**RESPONSES TO PUBLIC COMMENTS ON
NUREG-2224, “DRY STORAGE AND TRANSPORTATION OF
HIGH BURNUP SPENT NUCLEAR FUEL,
DRAFT REPORT FOR COMMENT”**

Division of Fuel Management
Office of Nuclear Material Safety and Safeguards
U.S. Nuclear Regulatory Commission
Washington, DC 20555-0001

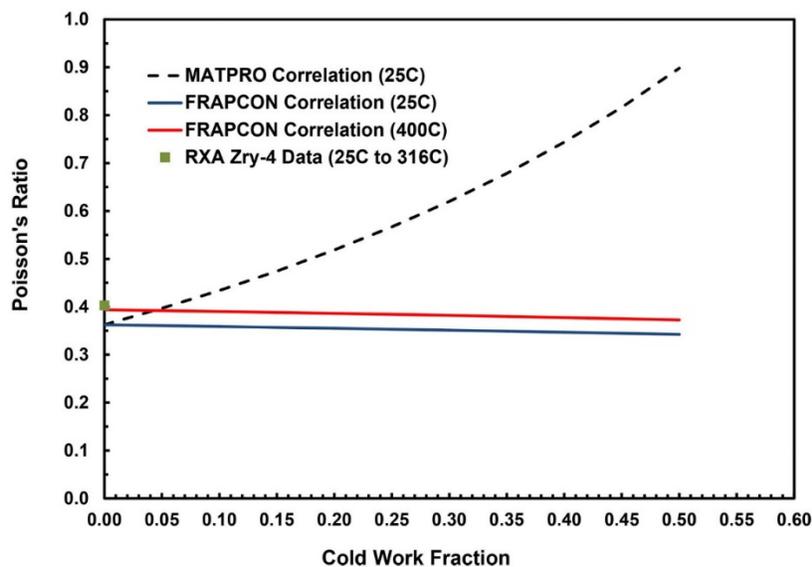
The commenter stated: “Mechanical Properties Data for Zr-based Cladding Alloys: The two Geelhood et al. references provide adequate guidance to the applicant for the mechanical properties of Zircaloy-2 (Zry-2), Zircaloy-4 (Zry-4) and to some extent ZIRLO. Both references

contain the same correlation for Young's modulus (E), which is a function of cold-work fraction, temperature, fast fluence, and excess oxygen (not relevant).

Only the 2nd reference (Geelhood et al, 2013 – please correct to 2014 in text and reference list) contains correlations for a much needed second elastic constant, which in this case is the shear modulus (G). For elastic analyses of isotropic materials, most stress-strain relationships are written in terms of E and Poisson's ratio (ν), which is generally in the range of 0.2 to 0.4 for metals and always <0.5 . Reviewers of license applications should be aware that E and G correlations used in FRAPCON-3.5, FRAPCON-1.5, and MATPRO are compared in Geelhood et al, 2014. Although not pointed out by the authors, the MATPRO correlation for G has an incorrect dependence on cold-work fraction (CW) that leads to unrealistic values of $\nu = E/(2G) - 1$. The FRAPCON correlation for G appears to be correct. The figure below shows the comparison among MATPRO-calculated ν , FRAPCON-calculated ν , and ν -data for recrystallized-annealed (RXA, $CW = 0$) Zry-4 in the 24°C–316°C temperature range [1]. The FRAPCON correlations for E and G give $\nu = 0.37 \pm 0.02$ in the 25°–400°C temperature range with no significant variation with CW , temperature, and fast fluence.
